Transmittal
Submittal Review Response

Re: **Project No.:** 253117-261237
Project Name: PSTA Clearwater Multimodal Transit Center
Client: Pinellas Suncoast Transit Authority

Submittal No.: **S-051200-002-F**
Title or Description: **Structural Steel Framing Canopy & Pavilion**
Type of Submittal: **Shop Drawing** **If other**
Status
Review Code: Code 4: Approved As Noted; Resubmit
Other:
Review Comments:

1 ME101 SECTION VIEW
(REF: C/S-SD-6)
(OTHERS NOT SHOWN FOR CLARITY)

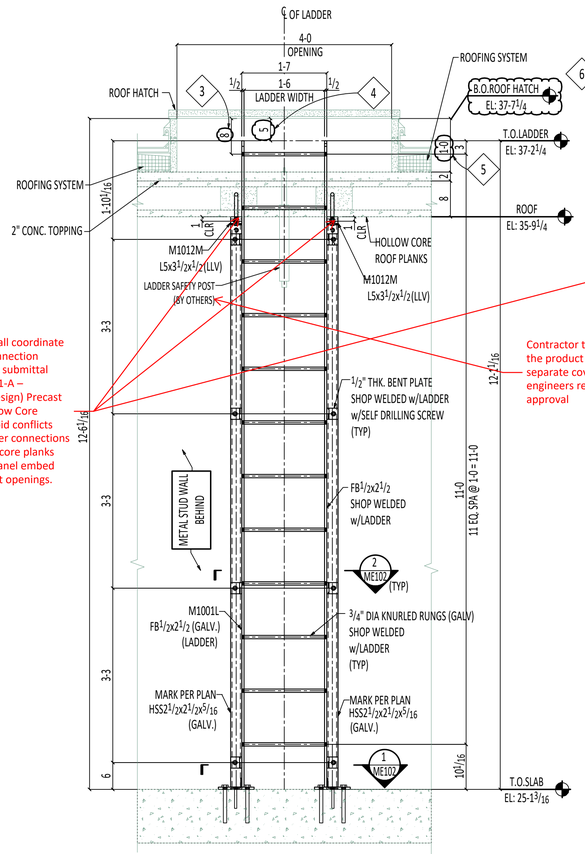
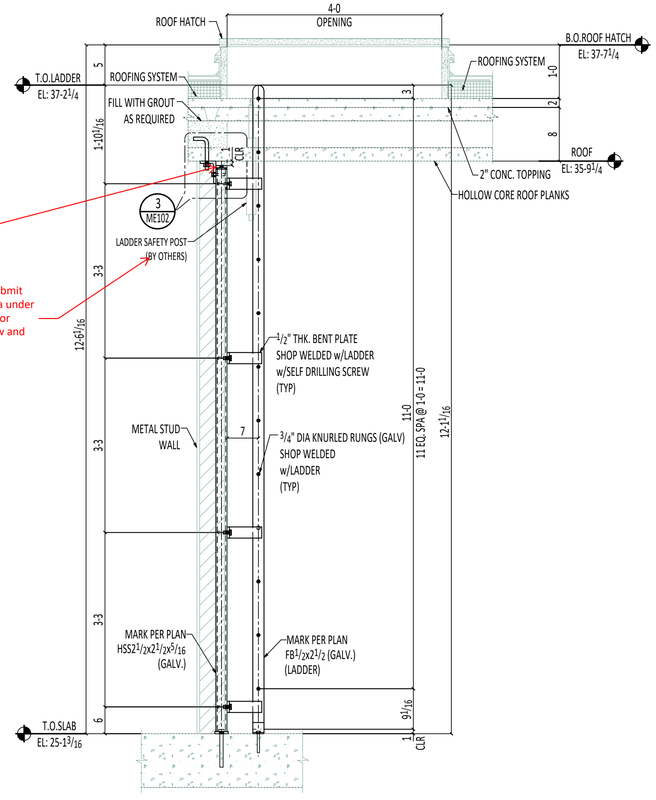
29. Comment 35 from the previous submittal remains unresolved and pertains to the roof hatch location at the Waiting Pavilion Building. As shown on Page 32 of 266, the roof hatch opening is currently located 7'-1" from the east exterior wall. At this location, the required ladder access and clear travel area overla the adjacent interior metal stud wall. Revise the roof hatch opening location by increasing the 7'-1" offset dimension as necessary to provide the required clearances and eliminate the conflict with the interior wall construction. Resubmit for review.

Contractor to submit the product data under separate cover for engineers review and approval

1. - PLEASE VERIFY AND CONFIRM THE OPENING DIMENSION & ITS LOCATION FROM WALL WITH ROOF HATCH MANUFACTURER. SINCE, WE HAVE CONFLICT IN ARCH DRAWINGS.
2. - PLEASE VERIFY AND CONFIRM THE CENTER OF LADDER LOCATING DIMENSION FROM WALL WITH ROOF HATCH MANUFACTURER.
3. - PLEASE VERIFY AND CONFIRM THE DIMENSION FROM BOTTOM OF ROOF HATCH TO CENTER OF TOP RUNG WITH HATCH MANUFACTURER.
4. - PLEASE VERIFY AND CONFIRM THE CLEAR DIMENSION BETWEEN BOTTOM OF ROOF HATCH TO TOP OF SIDE RAIL WITH HATCH MANUFACTURER.
5. - PLEASE VERIFY AND CONFIRM THE DIMENSION FROM BOTTOM OF ROOF HATCH TO TOP OF TOPPING WITH HATCH MANUFACTURER.
6. - PLEASE VERIFY AND CONFIRM THE BOTTOM OF ROOF HATCH ELEVATION WITH HATCH MANUFACTURER.

TYPICAL BOLLARD DETAIL

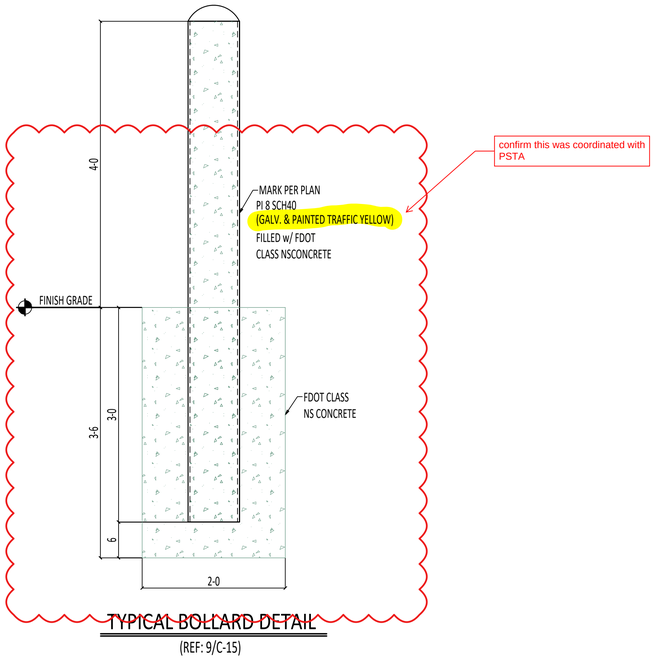
confirm this was coordinated with PSTA

36. Bollard finish / selection
ME112 is revised to identify bollards as galvanized and painted traffic yellow.

ONE BEAM 1030B - G

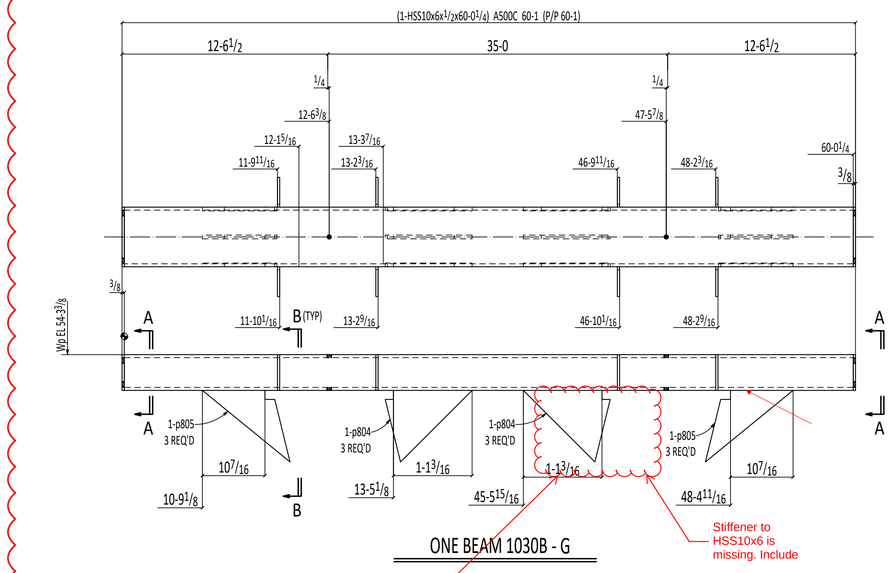
Stiffener to HSS10x6 is missing. Include

ONE BEAM 1185TR-G

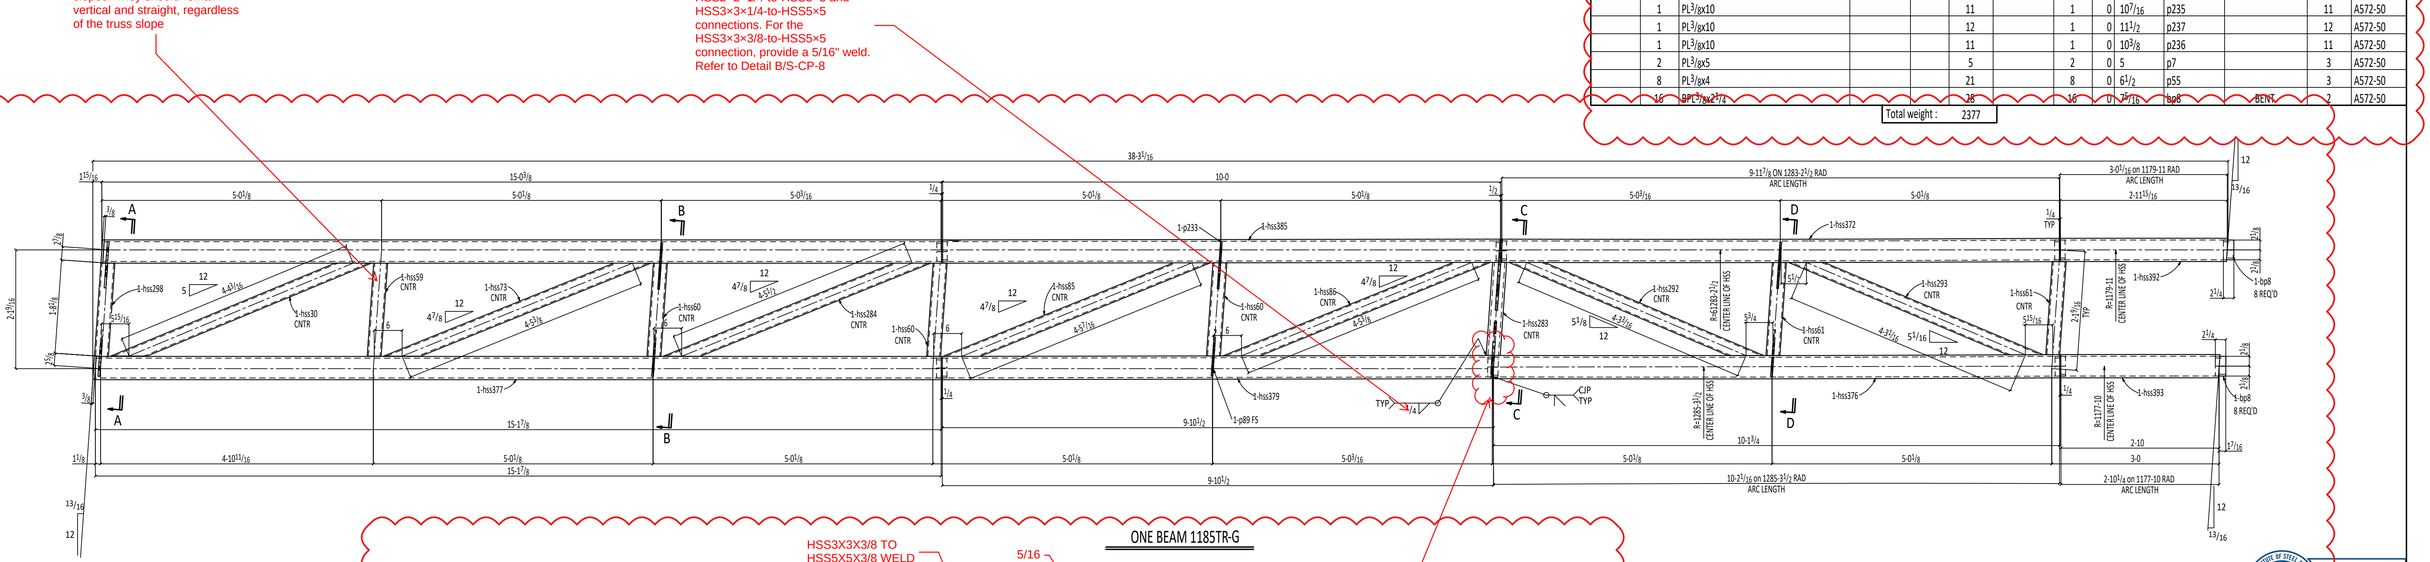
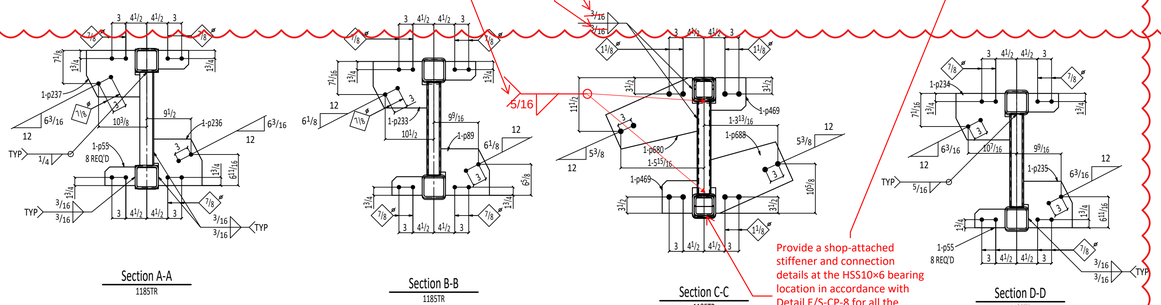
The 1/4" weld applies to the HSS2×2×1/4-to-HSS5×5 and HSS3×3×1/4-to-HSS5×5 connections. For the HSS3×3×3/8-to-HSS5×5 connection, provide a 5/16" weld. Refer to Detail B/S-CP-8

Provide a shop-attached stiffener and connection details at the HSS10×6 bearing location in accordance with Detail E/S-CP-8 for all the longitudinal trusses RT-1. See comments on E118 for further clarification

ONE TRUSS 1191TR-G

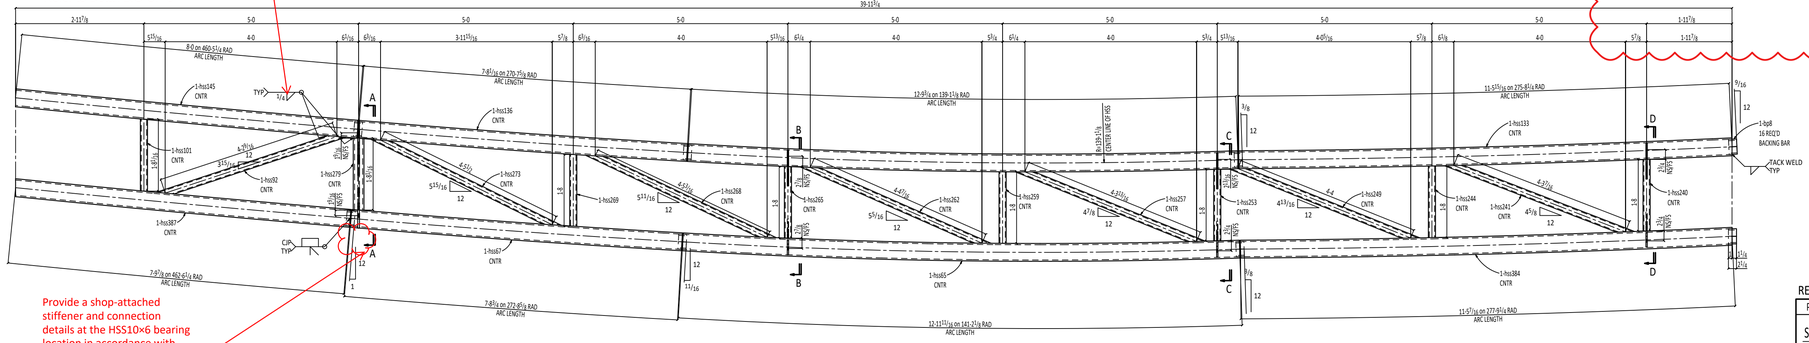
The 1/4" weld applies to the HSS2×2×1/4-to-HSS5×5 and HSS3×3×1/4-to-HSS5×5 connections. For the HSS3×3×3/8-to-HSS5×5 connection, provide a 5/16" weld. Refer to Detail B/S-CP-8

Provide a shop-attached stiffener and connection details at the HSS10×6 bearing location in accordance with Detail E/S-CP-8 for all the longitudinal trusses RT-1. See comments on E118 for further clarification
